2. AMENDMENT/MODIFICATION NO. 0006	3. EFFECTIVE DATE 20 SEP 2009	4. REQUISITION/PURCHASE REQ.	PROJECT NO. (if applicable)
---------------------------------------	----------------------------------	------------------------------	-----------------------------

8. NAME AND ADDRESS OF CONTRACTOR (No., street, county, State and ZIP Code)	<input checked="" type="checkbox"/>	9A. AMENDMENT OF SOLICITATION NO. N40085-09-R-5051
	<input type="checkbox"/>	9B. DATED (SEE ITEM 11) 01 September 2009
	<input type="checkbox"/>	10A. MODIFICATION OF CONTRACT/ORDER NO.
	<input type="checkbox"/>	10B. DATED (SEE ITEM 13)

DESIGN/BUILD Q891 SOF SMALL ARMS RANGE (FT STORY) NAB LITTLE CREEK, NORFOLK VIRGINIA

C-101

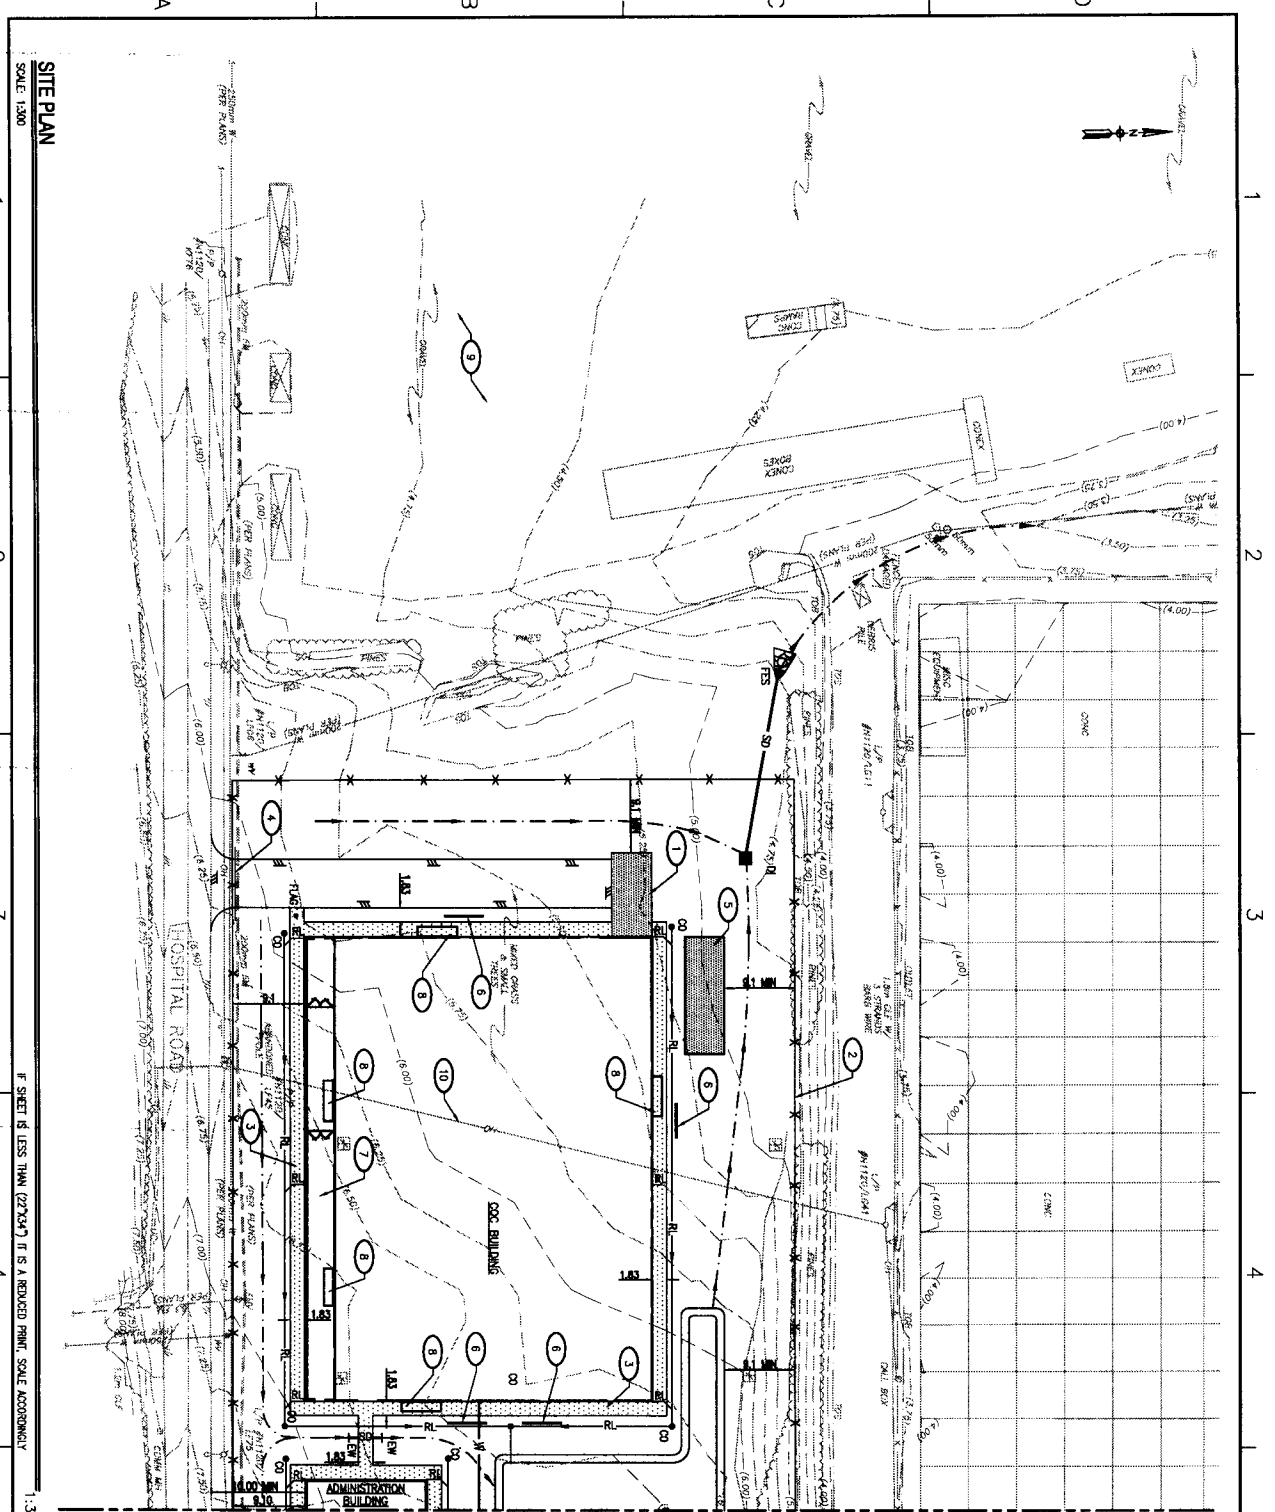
10	RFP drawing C-102 shows contour lines. RFP drawing C-101 does not show contour lines. Can sheet C-101 be reissued showing contour lines, so earthwork can be priced?		<i>Revised drawing with contour lines is attached.</i>
11	Part 3, G102005 Utility Relocation says to comply with the requirements of the utility provider concerning the utility relocation of (1) telephone systems, and (2) natural gas. What work will the D/B contractor have to do in this regard, so it can be priced?		<i>D/B contractor will need to reroute the telephone system underground around the footprint of the building.</i>
12	RFP drawing C-101 shows an existing OH utility running over the CQC building. During the pre-bid site visit it appeared this OH utility was a telephone/comm. line. Will the Government have this line relocated or is it the D/B contractor's responsibility to relocate?		<i>It is the D/B contractor's responsibility to relocate the existing overhead utility.</i>

ADDED EXISTING CONTOURS AND KEYNOTE 10 9/14/09 RMS
